SUBJECT: Forwards addl info in response to NRC 800728 ltr re
 containment ventilation isolation. Three oversize electrical
 drawings encl. SEE DRAWINGS

Re: Turkey Point Units 3 & 4
Docket Nos. 50-250 and 50-251
Containment ventilation isolation

ATTACHMENT

Fig. J1 (165A7678-1) Outline, Panel Drilling and Internal Connection Diagram for HEA61E Relay

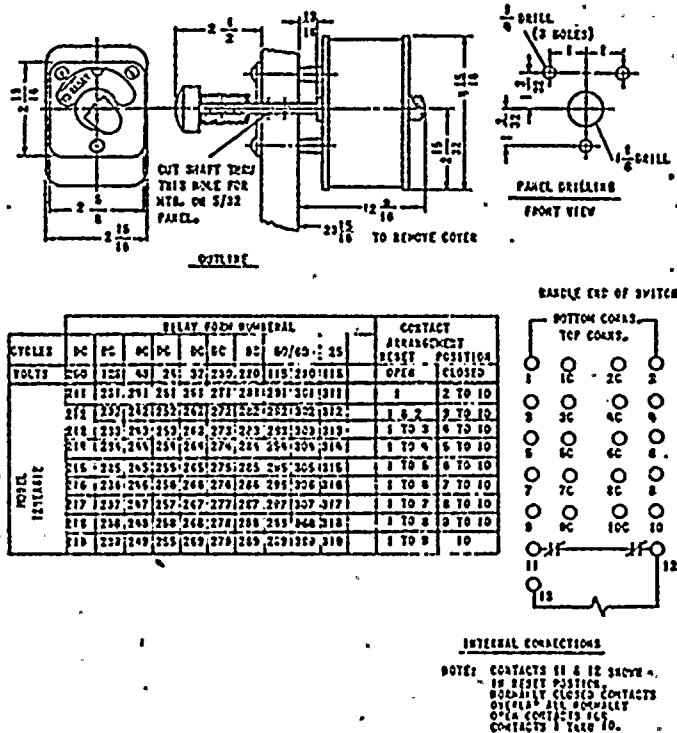
What is the memory element in the CVI control circuit shown on FPL drawing 5610-T-LI? Is it an MG-6 relay? Shown on what drawing? Please send drawing. Also, please send drawings 5610-E-25, sheet 59, E-389, and lesson 45. What is the form of switch QR50? Momentary? Key lock?

The memory element in the CVI control circuit shown on FPL drawing 5610-T-L1, sheet 11, is device 3-86/CIV1 shown on FPL drawing 5610-E-28, sheet 31F. This is a General Electric type HEA61 relay which is a "lock-out" relay. This device locks in the energized position, requiring manual operation by turning it clockwise to reset it to the de-energized position. The designation of "QR50 and QR51" on FPL drawing 5610-T-L1, sheet 11, refers to the location of these relays. QR50 and QR51 are the containment isolation relay racks. The "switch" shown in the manual operating handle of the relay. (See attached General Electric drawing). This handle turns to reset, however, the relay will not maintain the de-energized (reset) position if the originating signal is still present.

5610-E-28 Sh. 31F	REV. 4
-------------------	--------

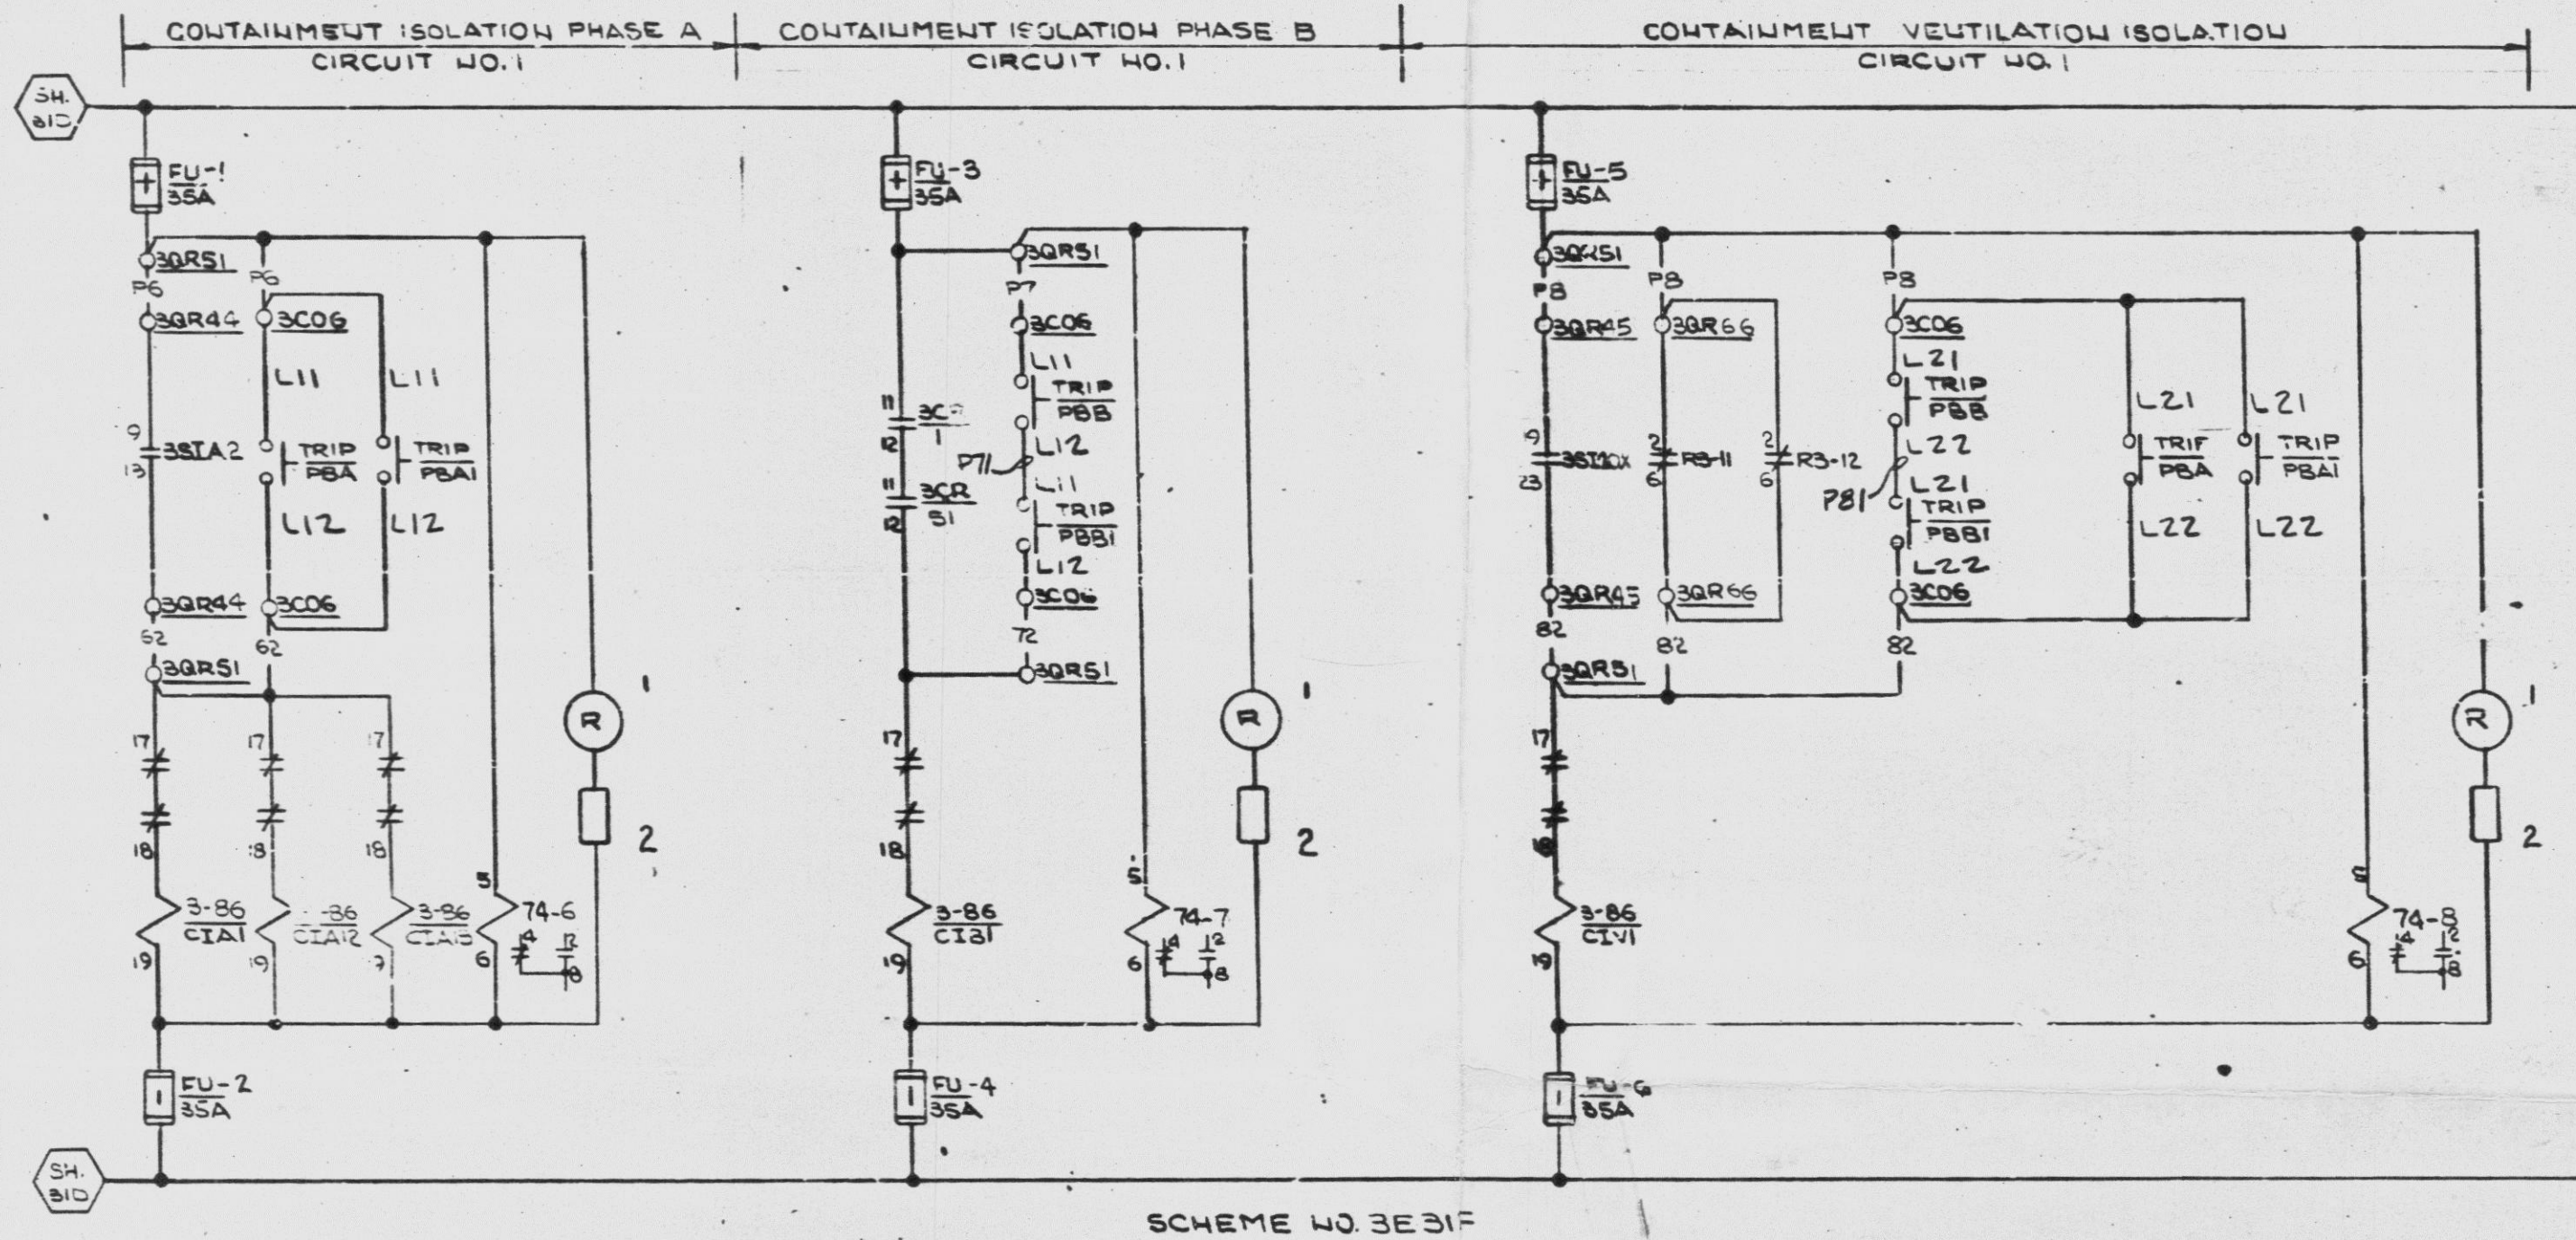
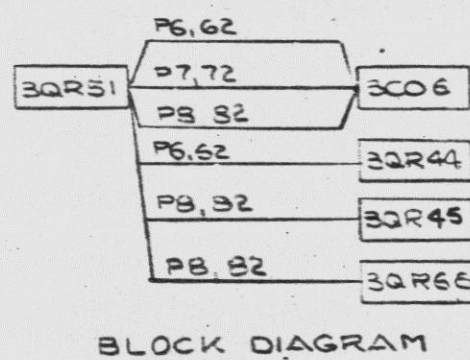
What is the function of the 86 "lock out relays"? Do they have memory function? Shown on what drawing? Send drawing if not 5610-E-28, sheet 31G. If they have memory function, how are they reset?
